145.2.5.6 Functions

Change Figure 145—16 on page 144 as shown

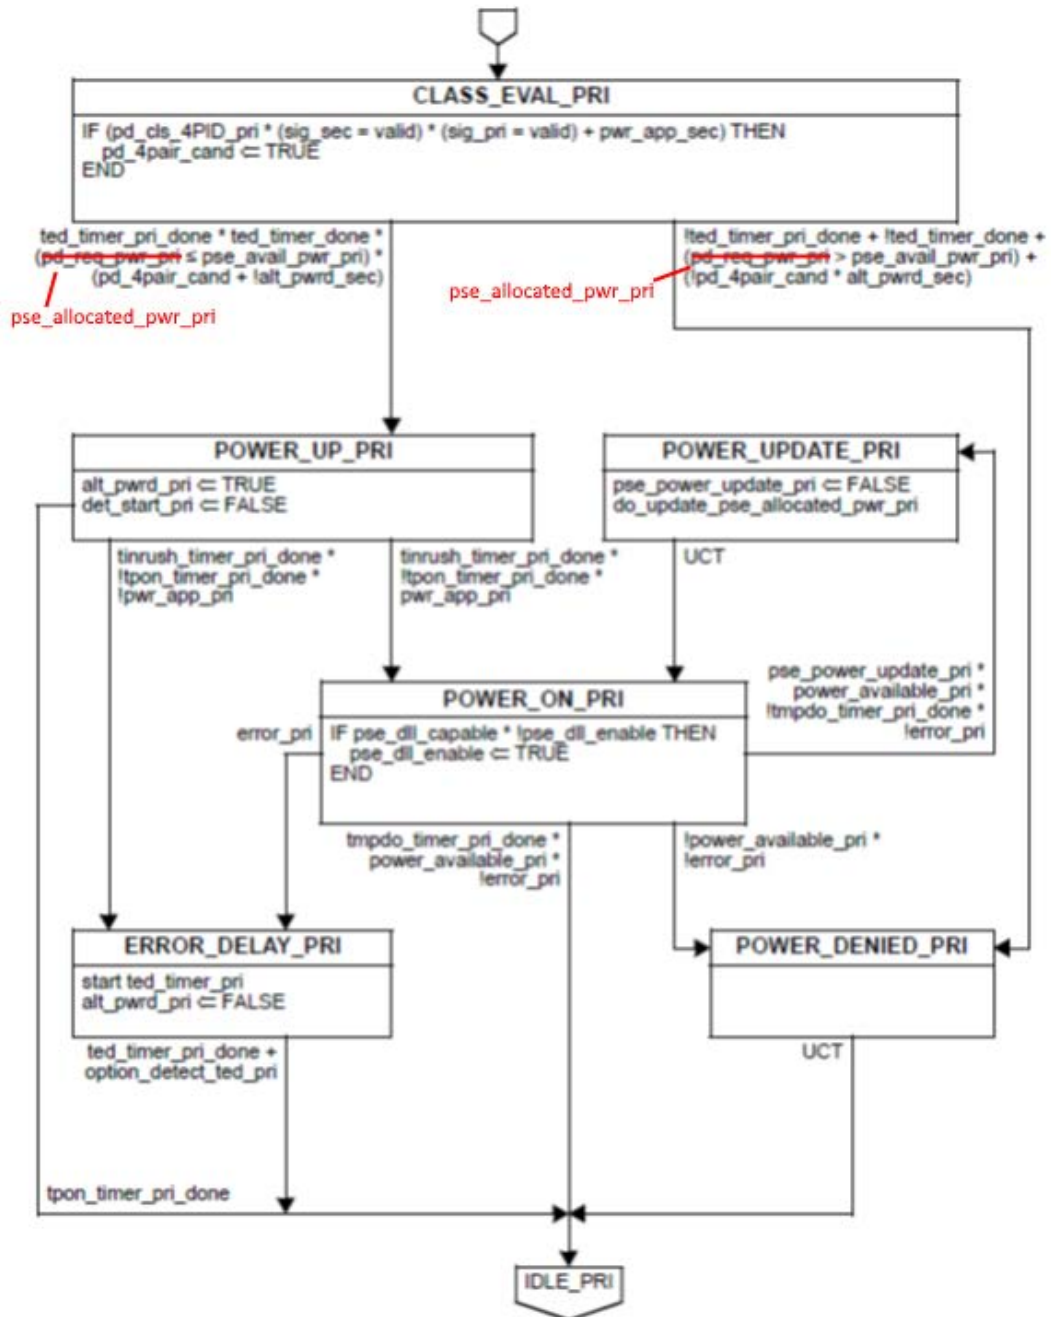
- Correctly reference pse_allocated_pwr_pri for result of classification and demotion

Figure 145–16—Secondary Alternative dual-signature semi-independent PSE state diagram (continued)

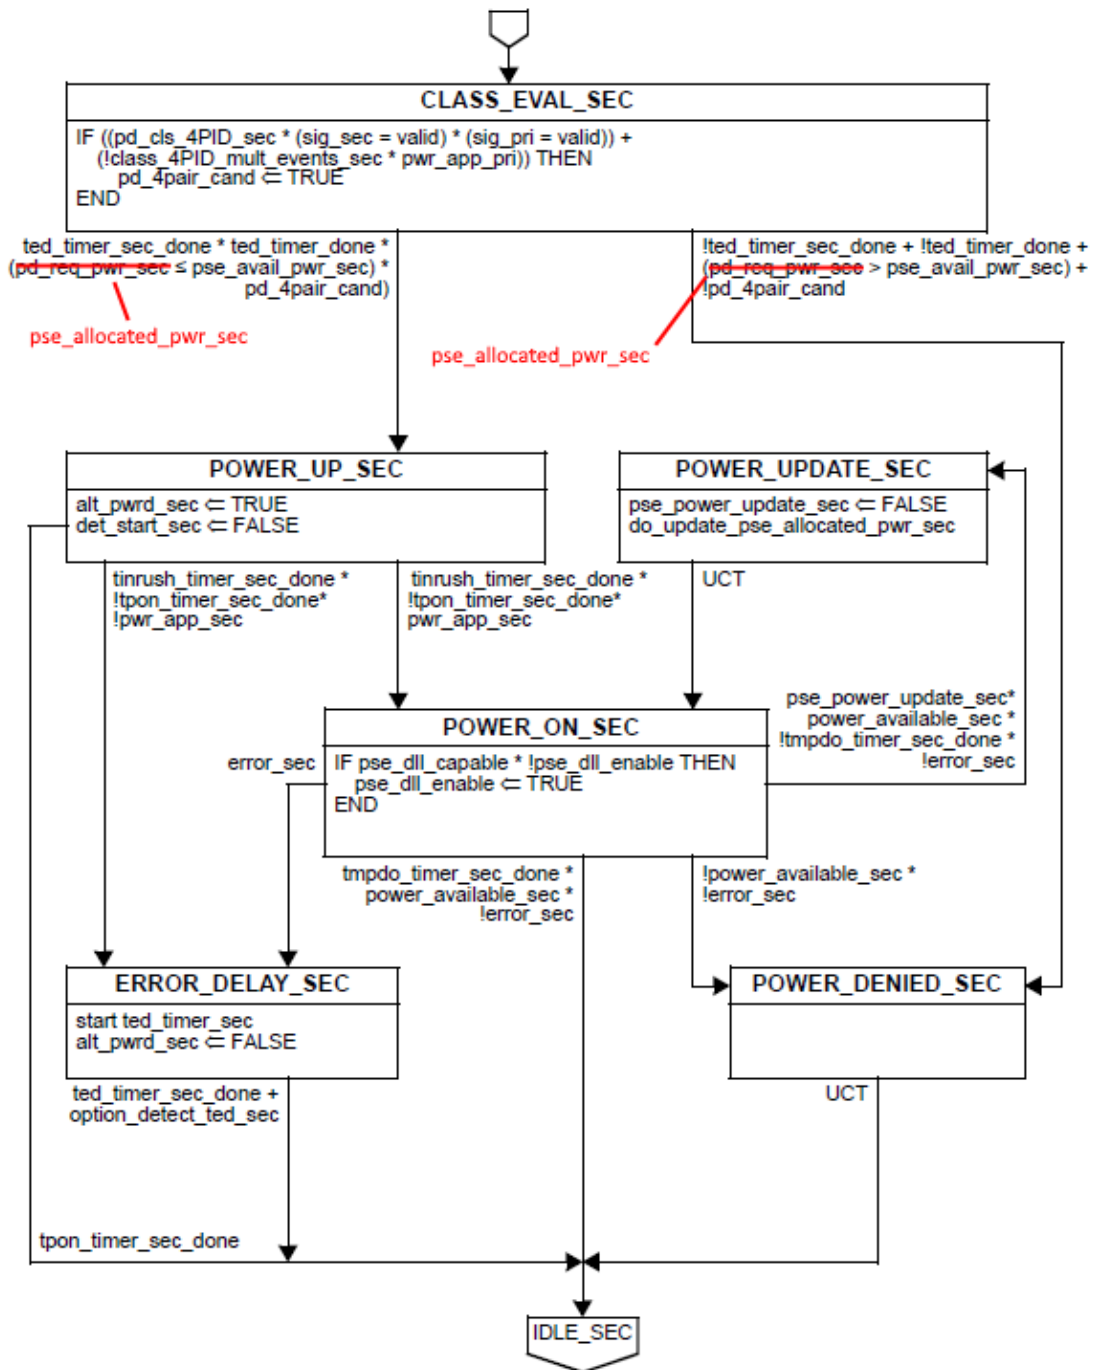
Change Figure 145—16 on page 148 as shown

- Correctly reference pse_allocated_pwr_sec for result of classification and demotion
